APPENDIX III

DETAILS OF CASK RESPONSE TO IMPACT ACCIDENTS

III.1 Finite Element Analysis of the Rail-Steel Cask

Figure III-4. Mesh of lid closure bolts and impact limiter attachment bolts

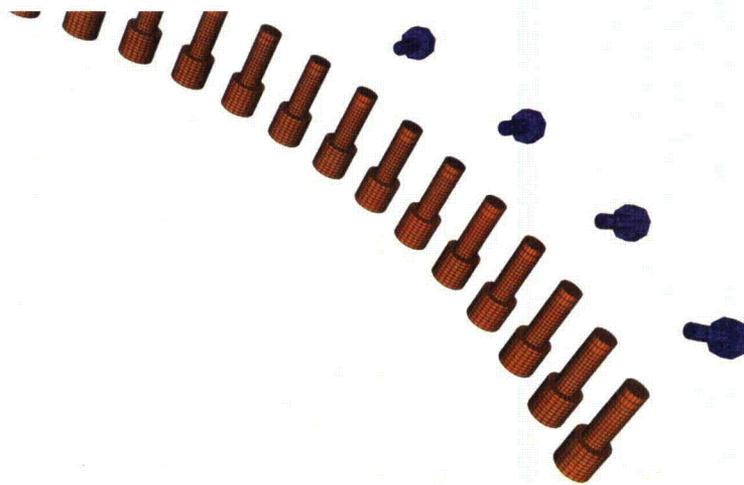
Comment [A6]: There is no discussion of preload in the bolts. Establishment of preload as an initial condition and subsequent evaluation of bolt stress is important and should either be explained or reasons for not considering it should be given. It is worthy of note that the bolt modeling here is much more refined than that employed in earlier published analyses of this cask.

Figure III-6. Orientation of cask model for material property definitions

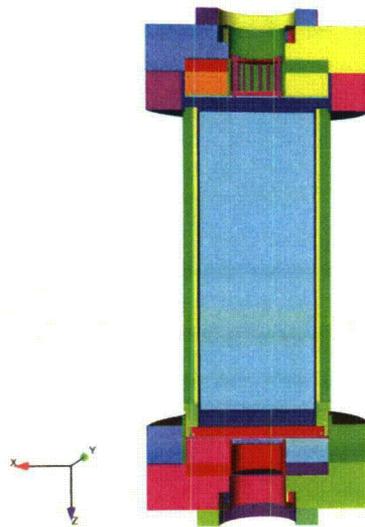
Comment [A5]: Note: Formatting issues with this figure are apparently the result of differences in versions of MS Word.

Figure III-27. Mesh of inner and outer lid closure bolts

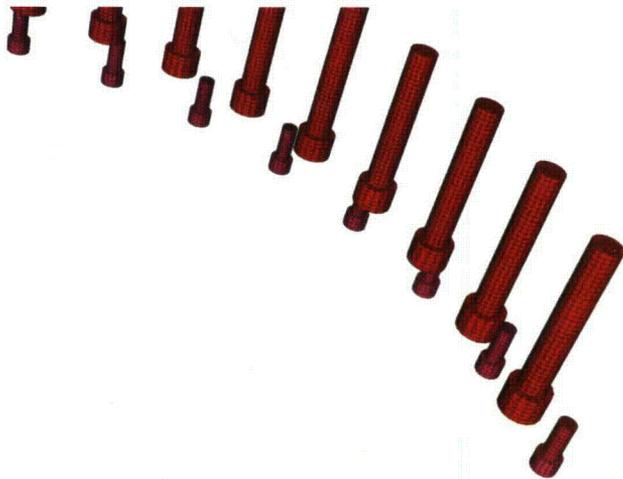
Comment [A12]: The omission of bolt preload should be explained.

Figure III-41. Gap opening locations for end impact orientation

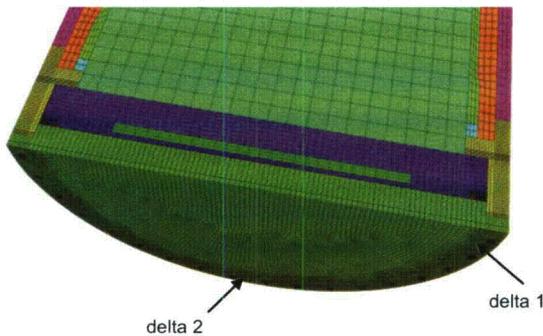
Comment [A13]: For section III.2.5 of the Appendix to stand alone, the results should be discussed here. At least a statement pointing to the discussion in Chapter 3, Sec 3.2.2, should be provided.

A note pointing to Table III-2, where "g" loads are given, would be useful to the general reader.

Figure III-61. Acceleration curves applied to fuel assembly beam model

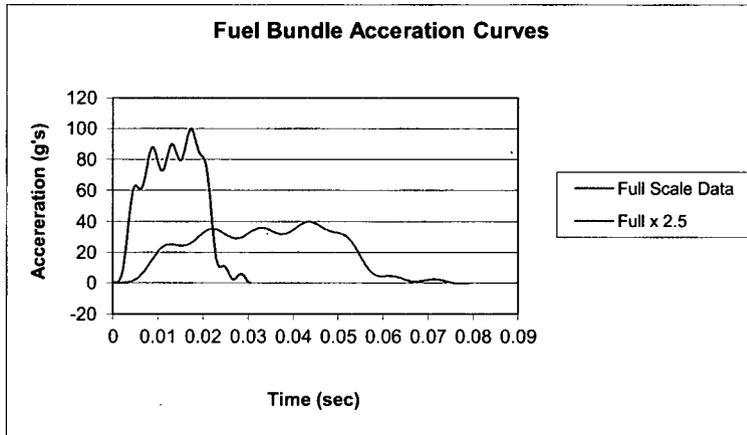
Comment [A23]: An explanation of the reason for not addressing the axial drop case would be helpful.

Figure III-65. Comparison of contact forces between solid rod and beam element rod

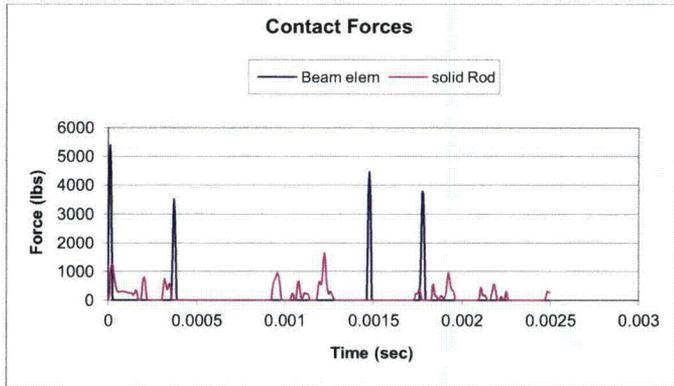
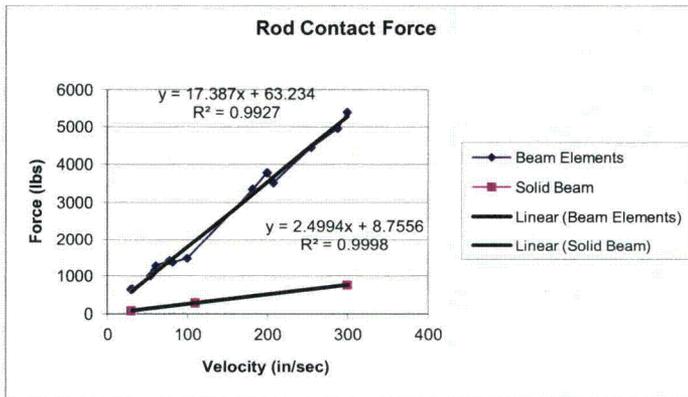
Comment [A24]: It appears that the analysis of the crossed rods is certainly conservative, with respect to contact stress, compared to the actual case where the rods are constrained to be essentially parallel. This should be noted in the discussion.
